Serial ATA Revision 2.6 Technical Errata

Change ID	ECN 021
Applicable Spec.	Serial ATA 2.6 Gold

6.4.1.1.1 External Serial ATA Connector Mechanical drawings, Figure 81 *frontal view drawing, with correct dimension as shown below:*

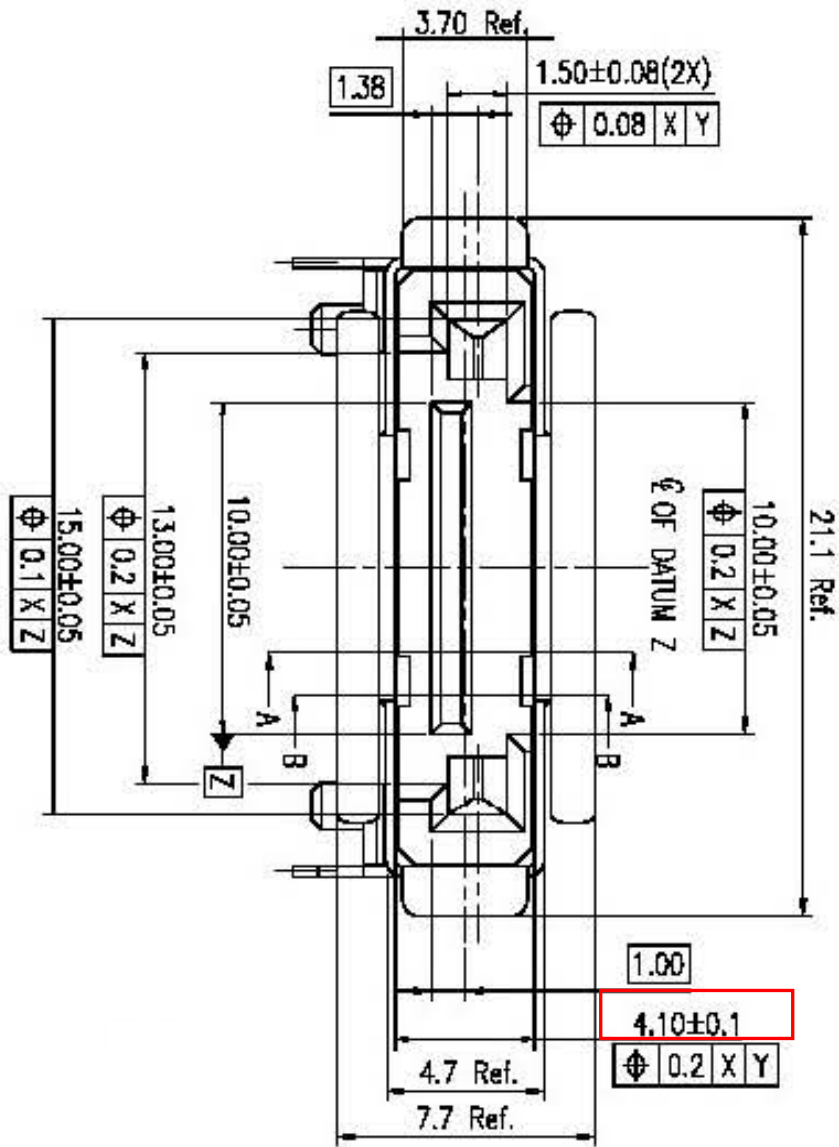
When the eSATA test document was initially drafted in preparation for interoperability workshop in Nov. 2007, the connector mechanical dimension for the plug internal height, [SATA v2.6 Specification, Section 6.4.1.1.1 External Serial ATA Connector Mechanical drawings](#), was found to be inconsistent between Figure 81 ($4.10\pm 0.1\text{mm}$) and Figures 82 through 85 ($4.00\pm 0.1\text{mm}$).

1. The external plug height dimension in the same Figures is consistent with 4.7mm (ref.)
2. There is only one receptacle connector (Figure 80) that mates with 5ea plug connectors (Figure 81-85).

6.4.1.1.1 External Serial ATA Connector Mechanical drawings, Figure 82-85, corrected frontal view dimension as shown below:

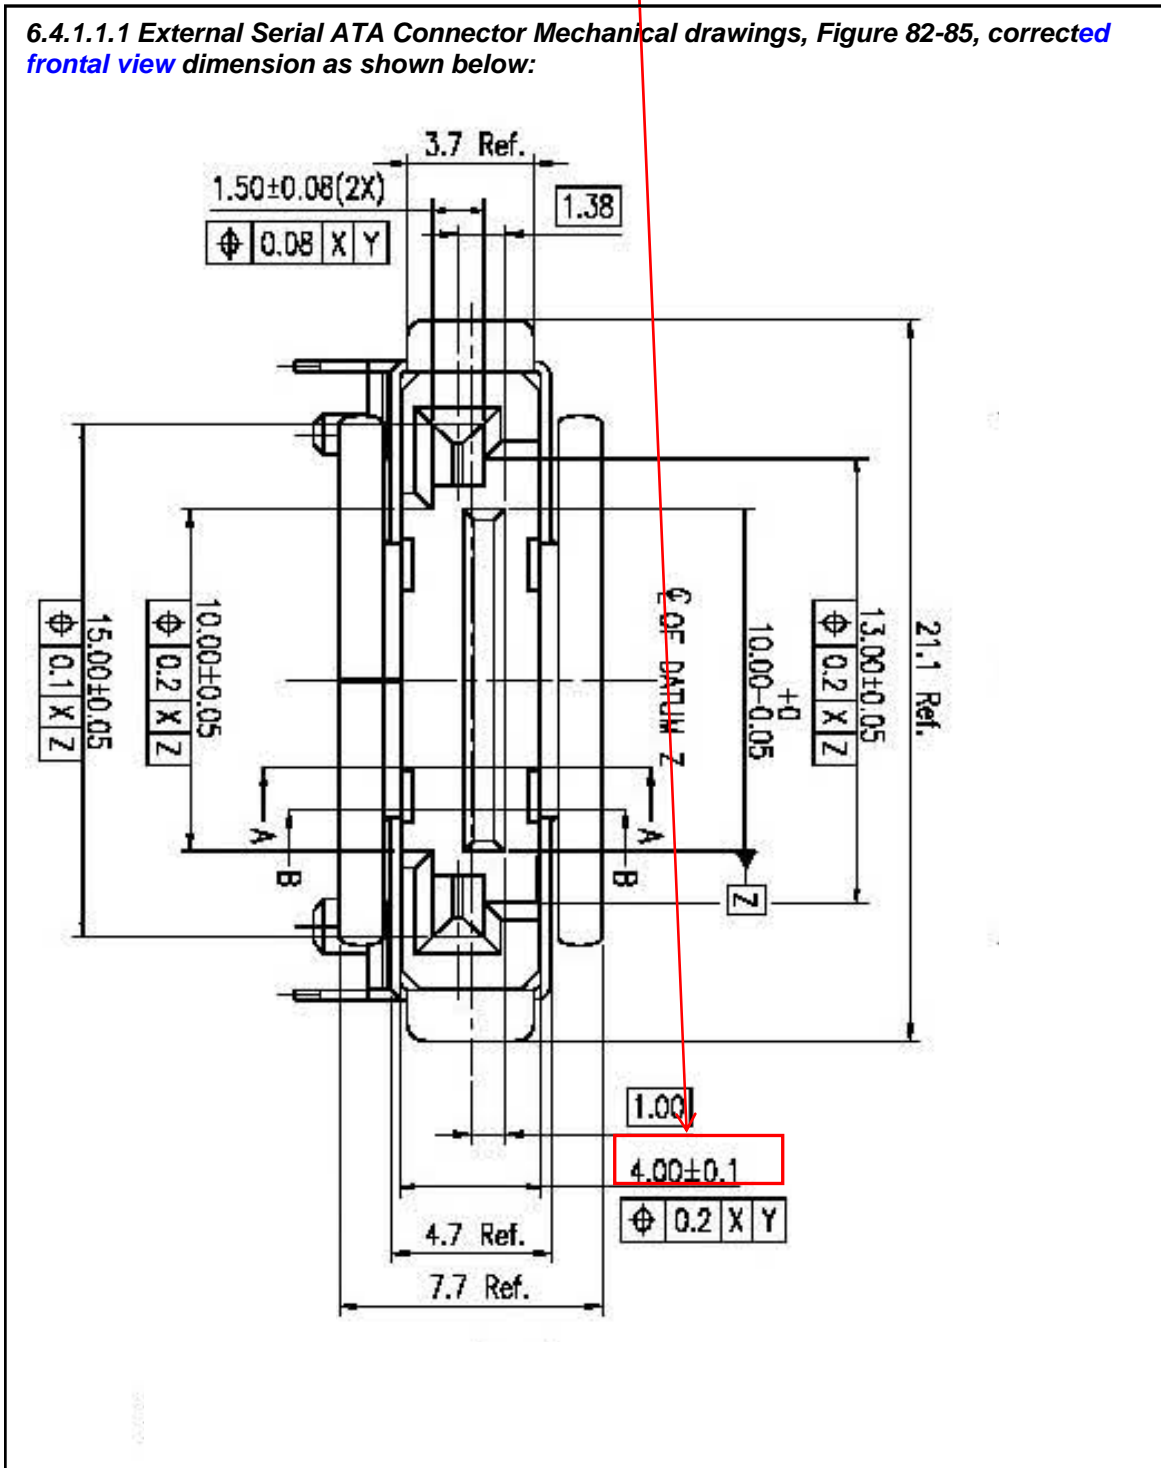
The frontal view drawing dimensions in Figure 82 through Figure 85 need to be corrected to $4.10\pm 0.1\text{mm}$, in the [SATA v 2.6](#) specification.

Description of the correction (cont'd): **(4.00±0.1 correct to 4.10±0.1) x4 places**
